S E R V I C E N O T E

8711B Network Analyzer**Serial Numbers:**

Failure to reach low end frequency on the 8711B and 8712B**To Be Performed By:** Agilent-Qualified Personnel or Customer**Duplicate Service Notes:** 8711B-01, 8712B-01**Parts Required:**

DATE: June 1996

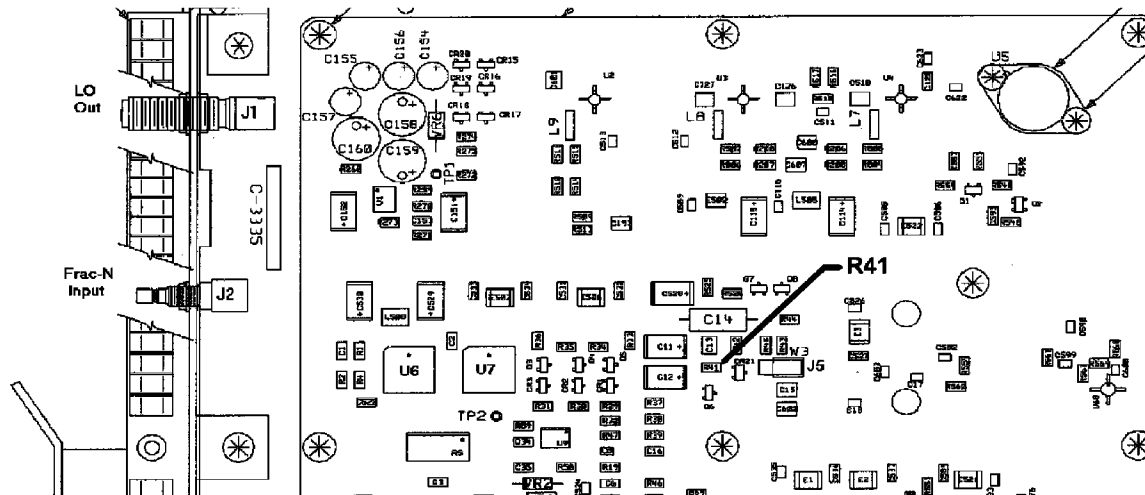
To solve this problem, a simple resistor change must be made to the A4 Source board (p/n 08712-60004). Please note that this resistor is a surface mount component, located under a metal shield, so extra caution will need to be exercised. Because these resistors are both fragile and inexpensive, it is recommended that several extra resistors be ordered. To implement this modification, change resistor A4R41 from its current value of 287 ohms (see note below) to 162 ohms (P/N 0699-1420). See figure for the exact location.

Many of these instruments may have an existing resistor value of 121 ohms instead of 287 ohms. This may cause a similar problem. In either case, replace the existing value with the 162 ohm resistor.

Unsolder A4R41 and replace it with the 162 ohm resistor. Use extreme caution since this is a surface mount component. Although probably not necessary, it is generally a good idea to redo adjustments #104 through #109. If the problem existed even when the analyzer was not in dither mode, then performing these adjustments is definitely required.

After the resistor has been replaced, permanently mark the front of the A4 board shield with "Modified per 8711B-01." It may also be helpful to mark the rear panel similarly.
